# Access Compliance Report

### (Curb Ramps)

Intersection ID: 28768	Main Street: FOUNTAINGROVE_DR	Cross Street: MAYCROFT_DR	Location: E
ADA ID: EE80396DEF01	Ramp Type: Perp	Initial Pass/Fail: Fail	Overall Compliance: No
Severity Score: 33.75			
Codes/Mitigation Info/Possible Solution		Field Measurements/Component Compliance

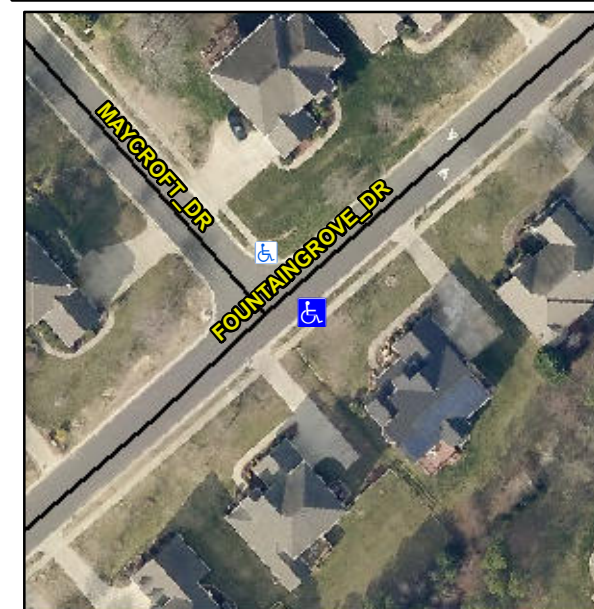
**R304.5.1, R304.2.2**

Compliance	Description	Data	Compliance	Description	Data
N/A	Ramp Length (in)	48.0	No	Ramp Slope (%)	12.9
No	Ramp Width (in)	42.0	Yes	Ramp XSlope (%)	0.4
N/A	Flare Type LT	N/A	N/A	Flare Type RT	N/A
N/A	Flare Slope LT (%)	N/A	N/A	Flare Slope RT (%)	N/A
N/A	Flare Traversable LT?	N/A	N/A	Flare Traversable RT?	N/A
N/A	Landing Length (in)	N/A	N/A	DWS Provided?	N/A
N/A	Landing Width (in)	N/A	N/A	DWS Contrast?	N/A
N/A	Landing Slope (%)	N/A	N/A	DWS Length (in)	N/A
N/A	Landing X Slope (%)	N/A	N/A	DWS Full Width?	N/A
N/A	Landing Curb? (Y/N)	N/A	N/A	DWS Offset (in)	N/A
N/A	Shared Landing?	N/A			
N/A	Gutter Ponding?	N/A	N/A	Gutter Slope (%)	N/A
N/A	Gutter Lip Ht (in)	N/A	N/A	Gutter X Slope (%)	N/A
N/A	Painted X Walk1?	No	N/A	Painted X Walk2?	N/A
	X Walk 1 Direction	To NW		X Walk 2 Direction	N/A
N/A	X Walk 1 Width (in)	N/A	N/A	X Walk 2 Width (in)	N/A
	X Walk 1 Slope (%)	2.3		X Walk 2 Slope (%)	N/A
	X Walk 1 X Slope (%)	1.9		X Walk 2 X Slope (%)	N/A

**Remove & Replace Entire Ramp.**
